# **THE STAR MODIFICATION 14 (MP 08\_0098)**

## **HERITAGE RESPONSE TO COMMENTS**

03 LINEAR LED TO BALUSTRADE - SECTION  
1404 SCALE N/A

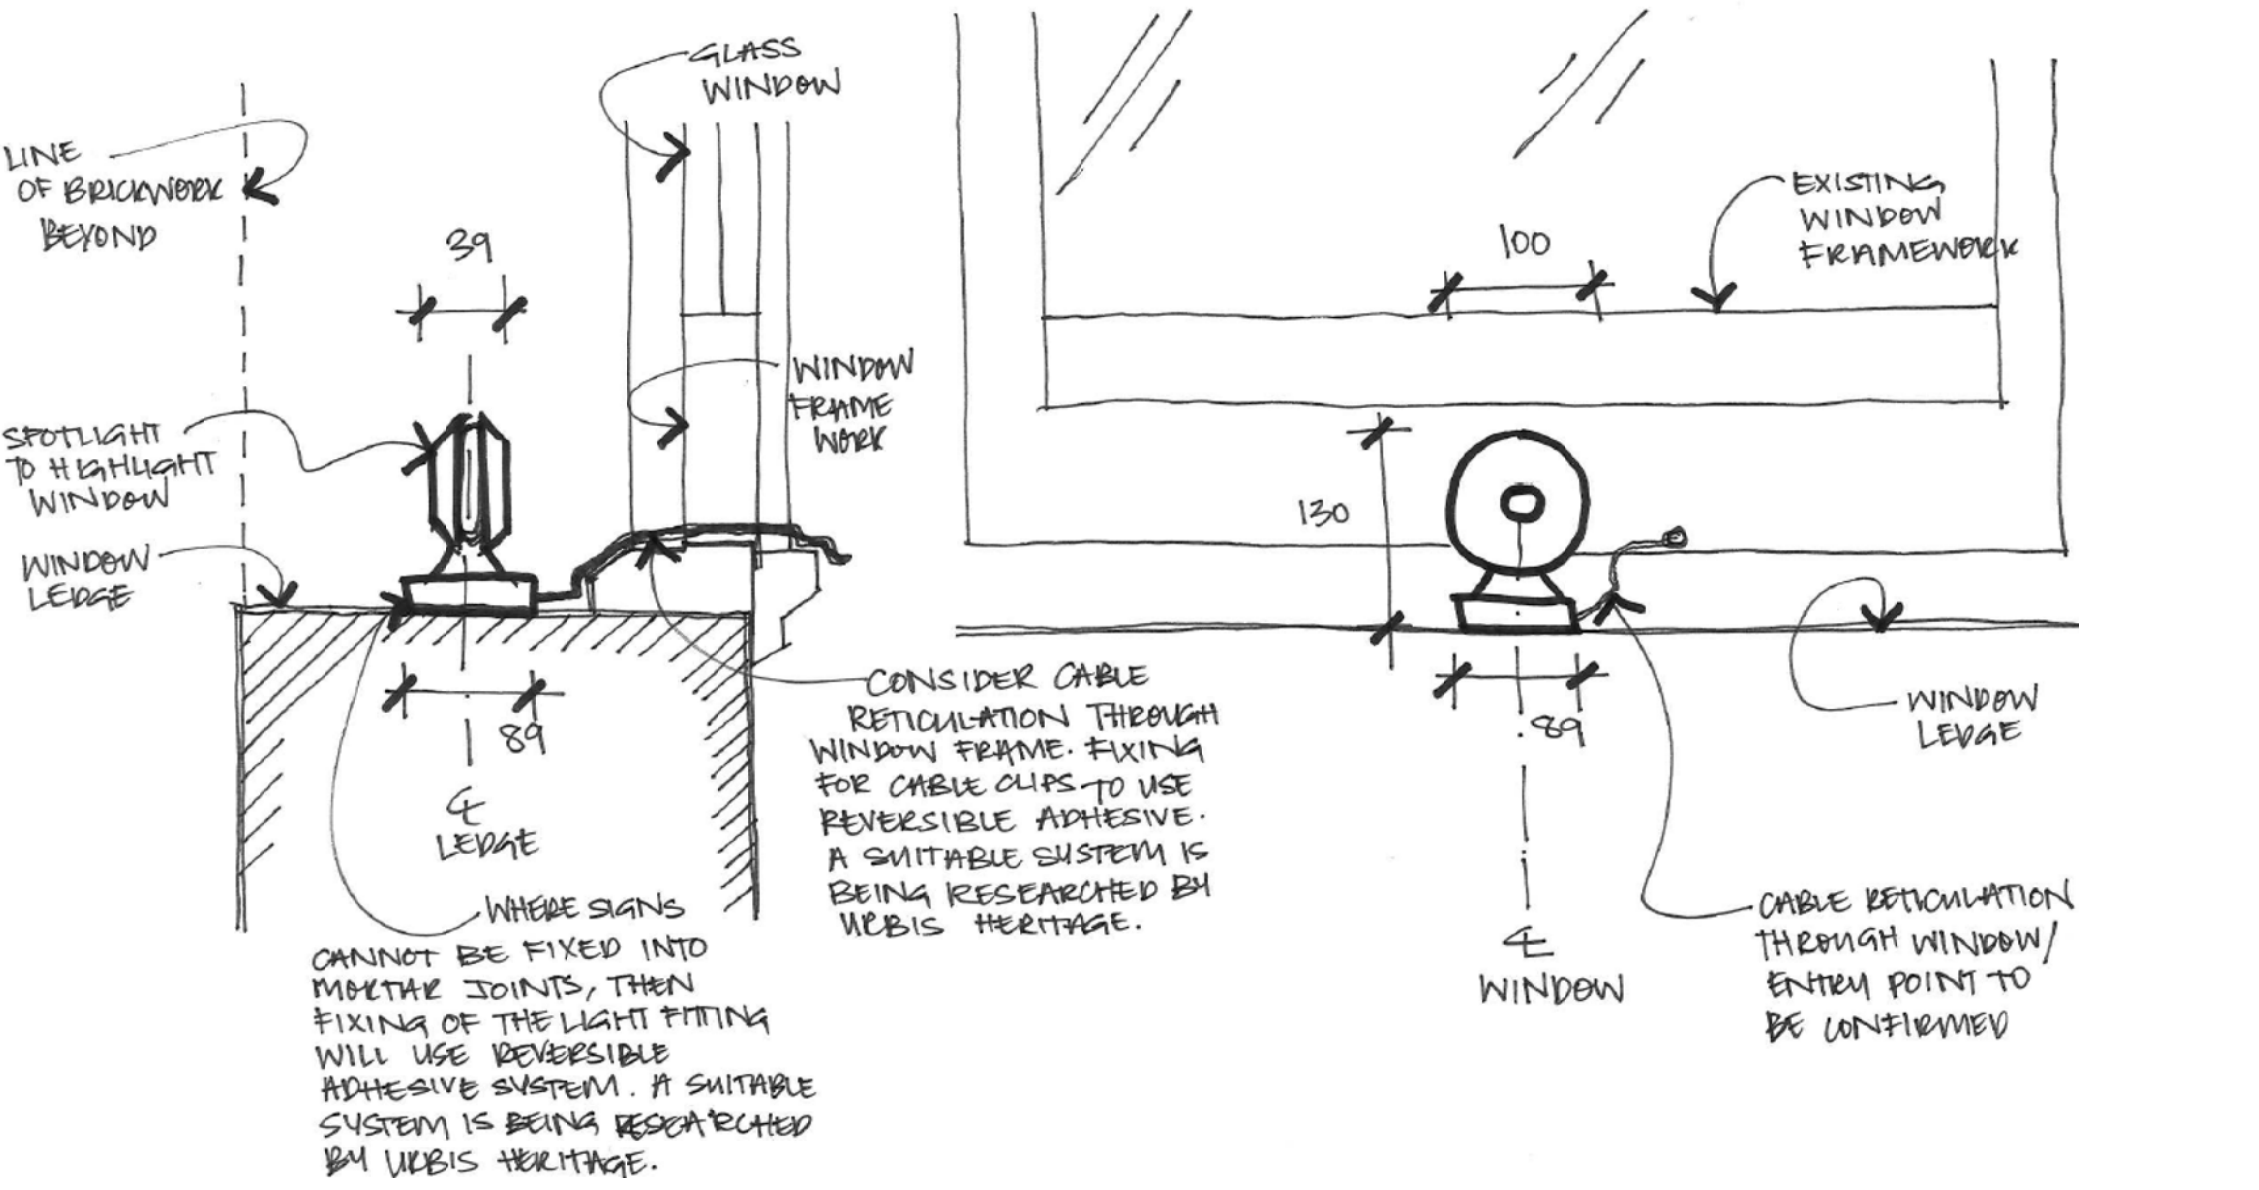
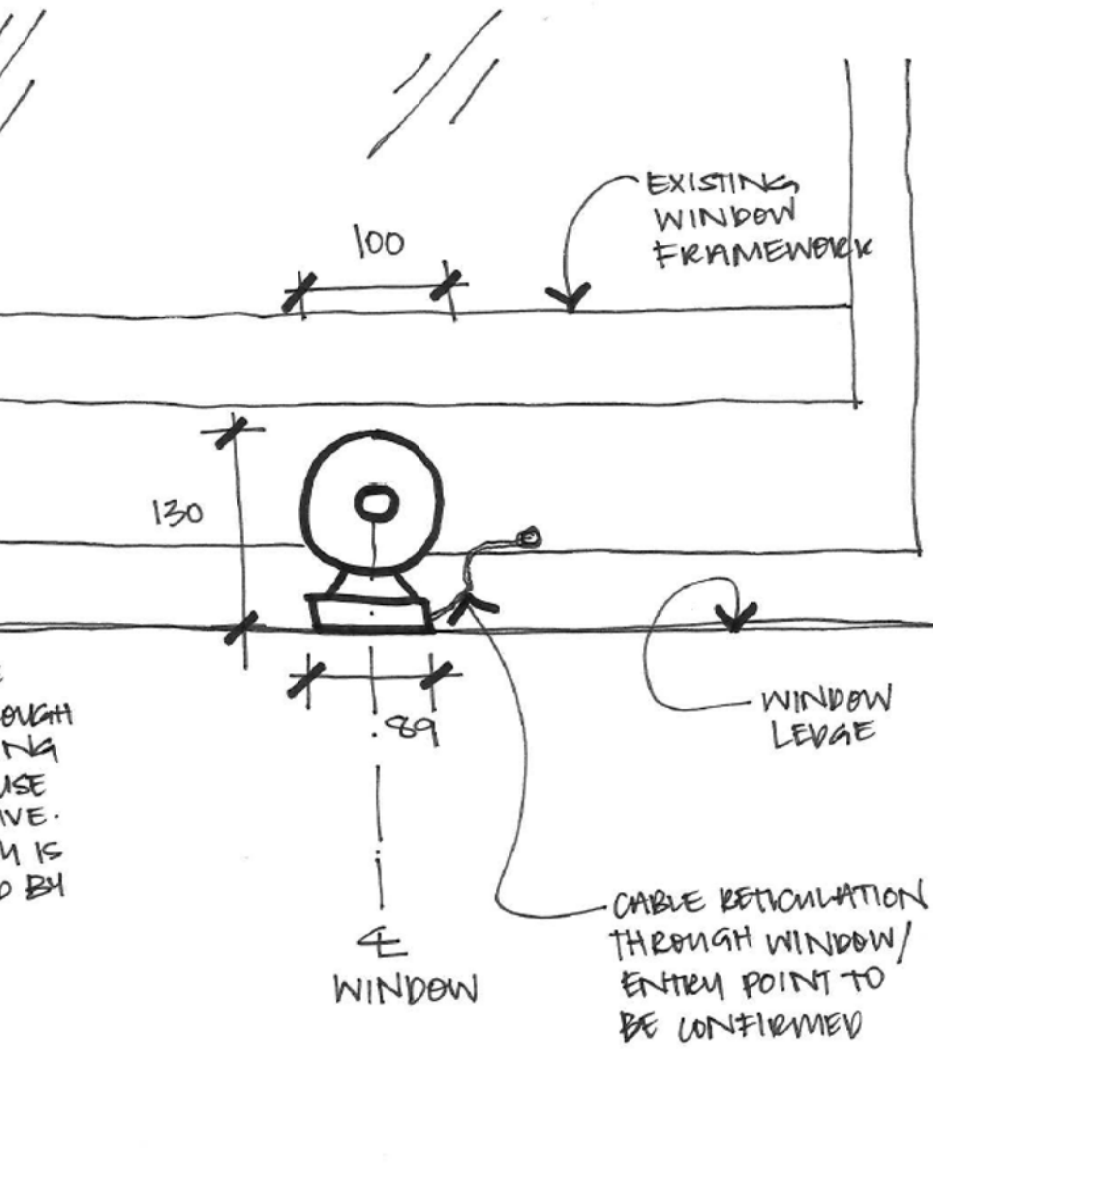
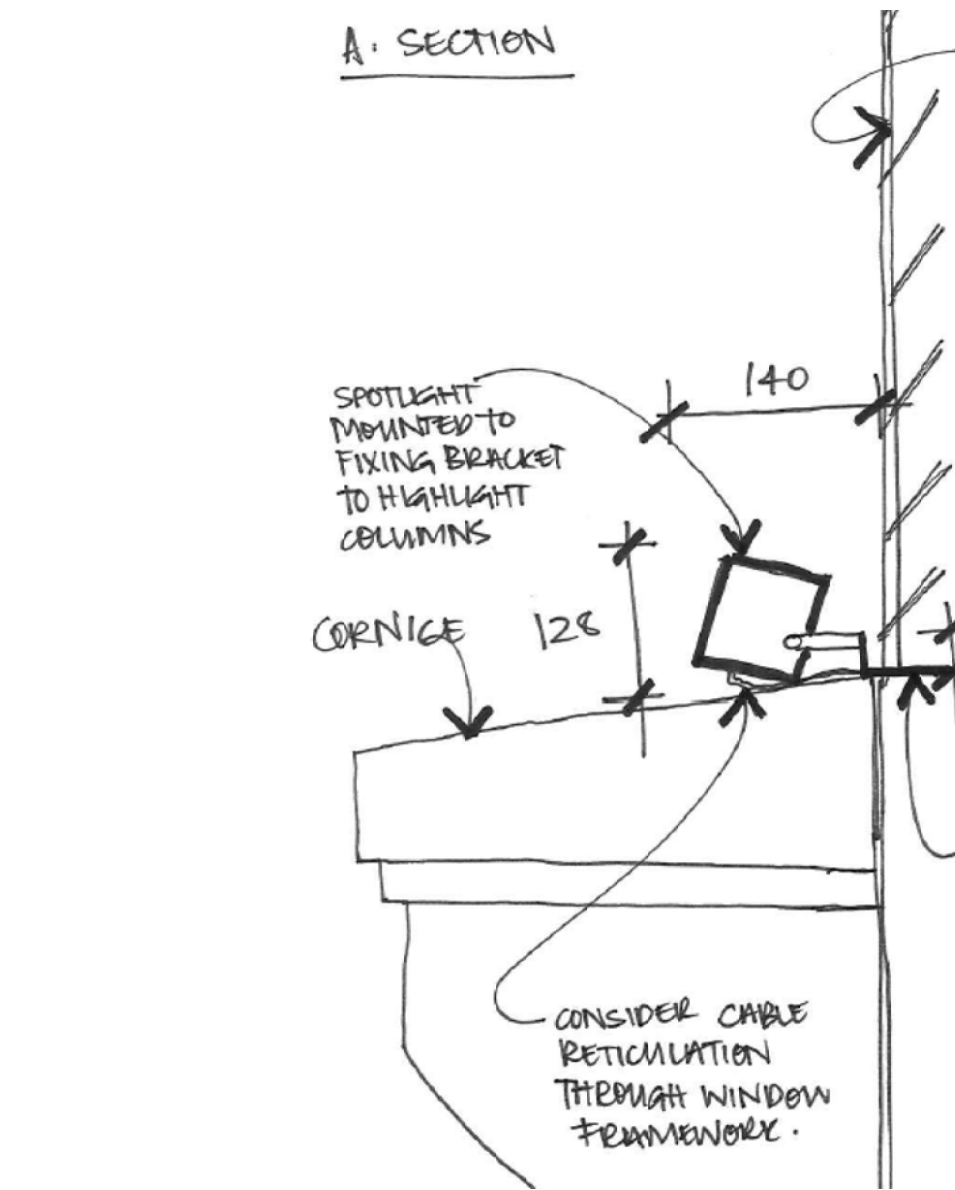
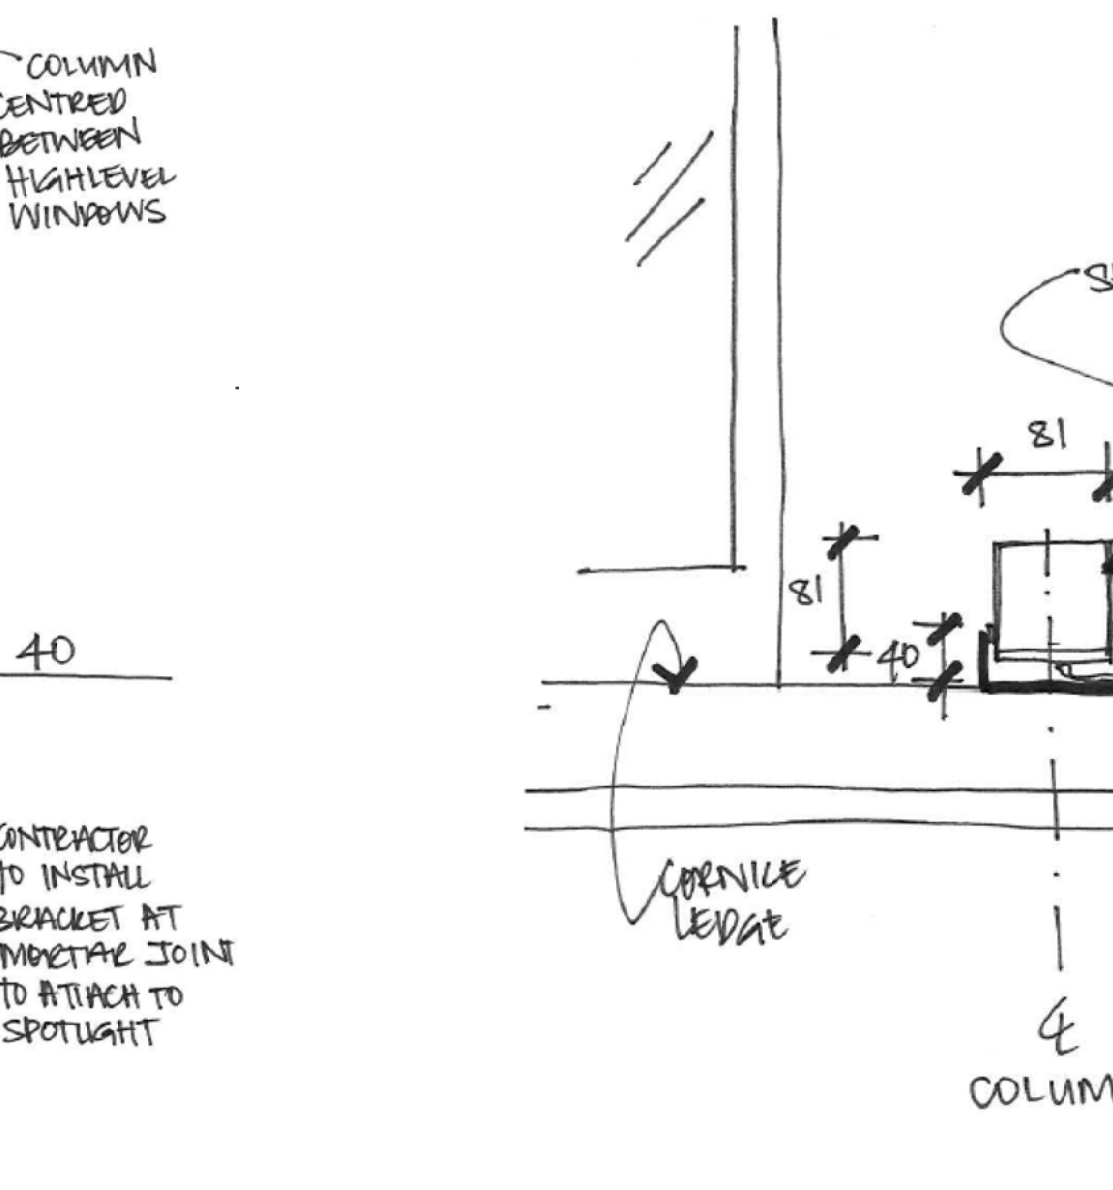
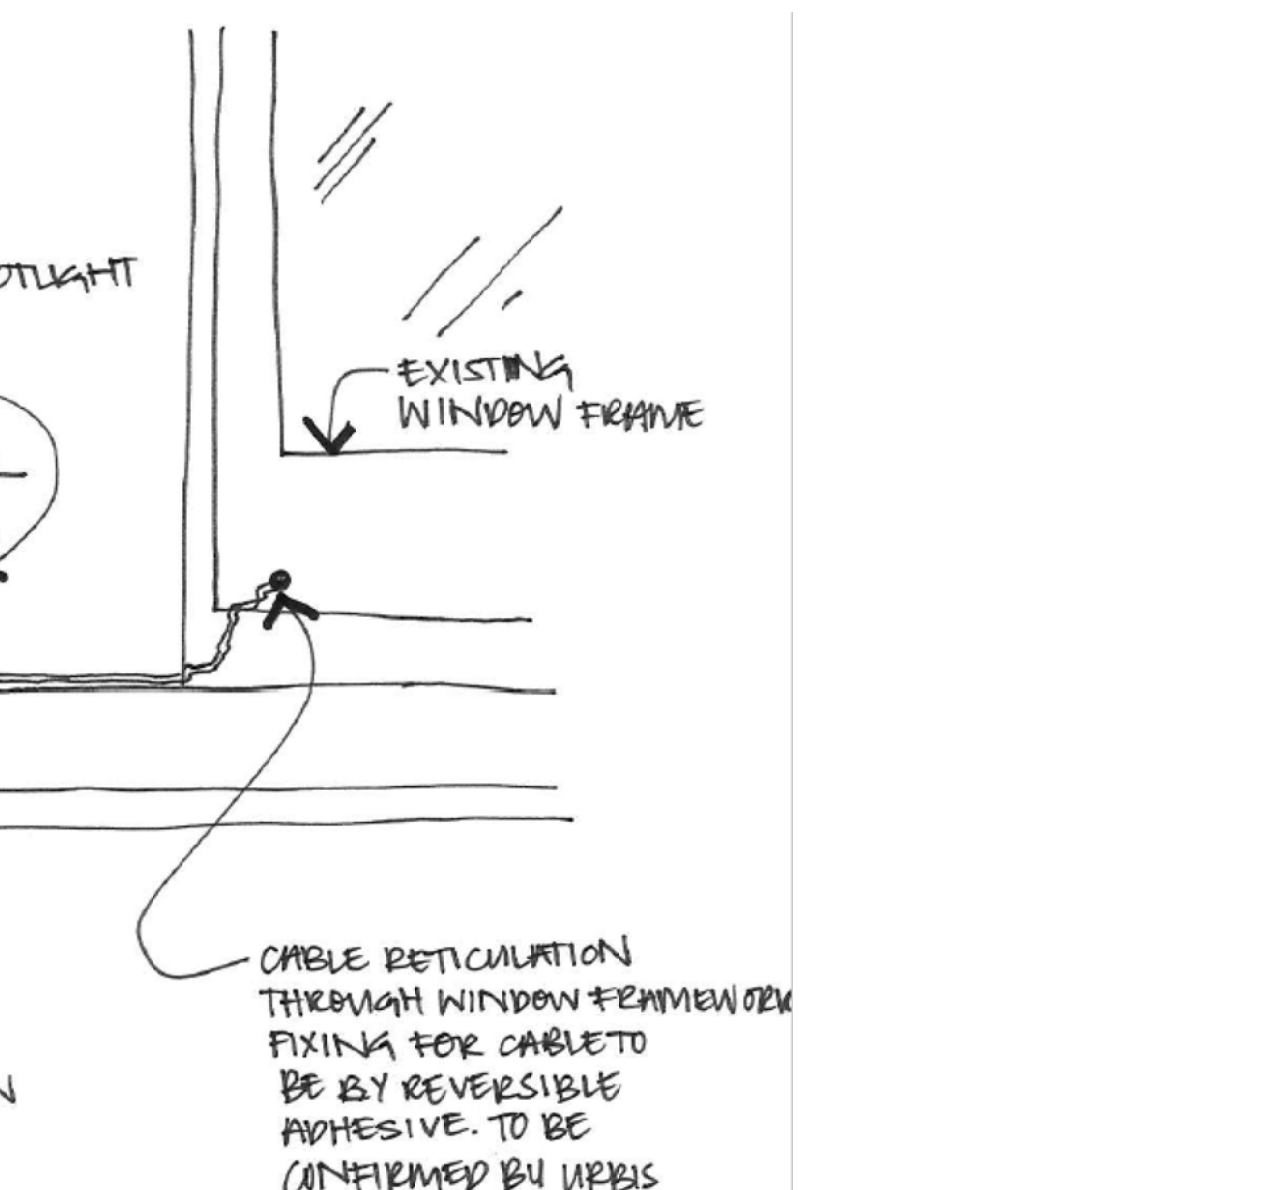
**(Refer Section 2.1 below for discussion).**
- *Any proposed changes to the external lighting to The SELS building should be in keeping with the recommendations made in the Heritage Impact Statement report, by URBIS Pty Ltd. In addition, a mock-up of the proposed lighting effects to the The SELS building should be organised, on site, to be inspected and approved by a suitably qualified heritage consultant.*

**(Refer Section 3.5 below for discussion).**
- *In relation to proposed lighting to the Pyrmont Street façade of the SELS Building, the report by Point of View includes a drawing “to convey design intent only” but the details are not shown on the submitted plans.*

The accompanying drawings have been provided as a mock up of the proposed lighting to The SELS. The lighting has been developed in accordance with the Dialux Render provided in Mod 14, the recommendations set down in the HIS by Urbis and with ongoing consultation with Urbis.

A methodology has been prepared by Urbis in collaboration with Point of View to ensure the appropriate treatment of the heritage item. In summary, the lighting strategy methodology ensures that the proposed strategy avoids penetrations into brick and stone fabric, and minimises the sizes of any penetrations through other fabric. The methodology statement also aims to minimise the visual impact of the light fittings and cabling.
